1	2 Ea.	P-201350-12	Interface Flange		A53 Grade B										
ITEM NO.	QTY	PART NO.	DESCRIPTION		MATERIAL SPECIFICATION										
BILL OF MATERIALS															
UNLESS OTHERWISE SPECIFIED TOLERANCES ARE: <table><tr><td>1 PLACE DIM ±.1/16</td><td>2 PLACE DIM ±.02</td><td>3 PLACE DIM ±.005</td><td>ANGLES ±1°</td></tr></table> 1. DIMENSIONS ARE IN INCHES 2. DIMENSION LIMITS HELD AFTER PLATING. 3. REMOVE BURRS AND SHARP EDGES .015 MAX. 4. MACHINED FILLET RADII .0150-.030. 5. MACHINED DIAMETERS ON A COMMON CENTERLINE CONCENTRIC WITHIN .005 6. PERPENDICULARITY & PARALLELISM OF MACHINED SURFACES .002 PER INCH. MAX .012 INCHES FOR SINGLE SURFACE. DO NOT SCALE DRAWING			1 PLACE DIM ±.1/16	2 PLACE DIM ±.02	3 PLACE DIM ±.005	ANGLES ±1°	APPROVALS		Monterey Bay Aquarium Research Institute 7700 Sandholdt RD. Moss Landing, CA 95039 PH: (408) 775-1700 R/V Rachel Carson Hydrophone Pole Interface Flange <table><tr><td>SIZE B</td><td>DWG. NO.</td><td>REV. A</td></tr><tr><td>SCALE NONE</td><td colspan="2">CAD FILE: Project Library\901125\R/V Rachel Carson</td></tr></table>	SIZE B	DWG. NO.	REV. A	SCALE NONE	CAD FILE: Project Library\901125\R/V Rachel Carson

1 PLACE DIM ±.1/16	2 PLACE DIM ±.02	3 PLACE

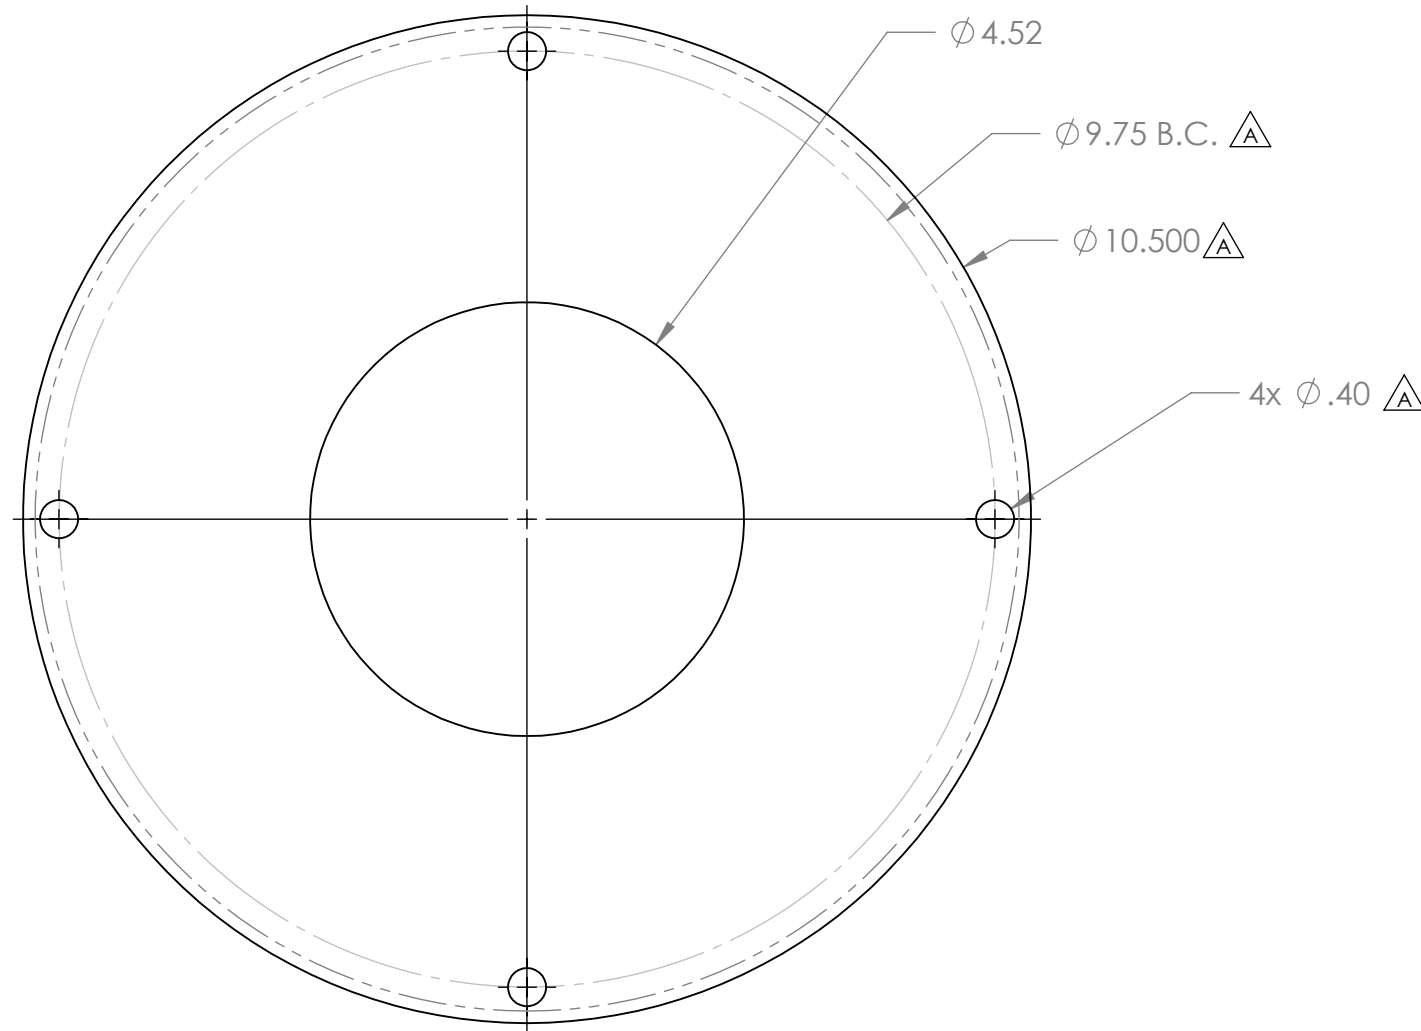
REVISIONS			
REV.	DESCRIPTION	DATE	APPROVED
	INITIAL RELEASE		
	1. Change OD to 10.5" 2. Change hole size to clearance for 3/8" bolt and B.C. to 9.75" dia. 3. Change fillet to .125".	31 Jul 2012	F. Shane
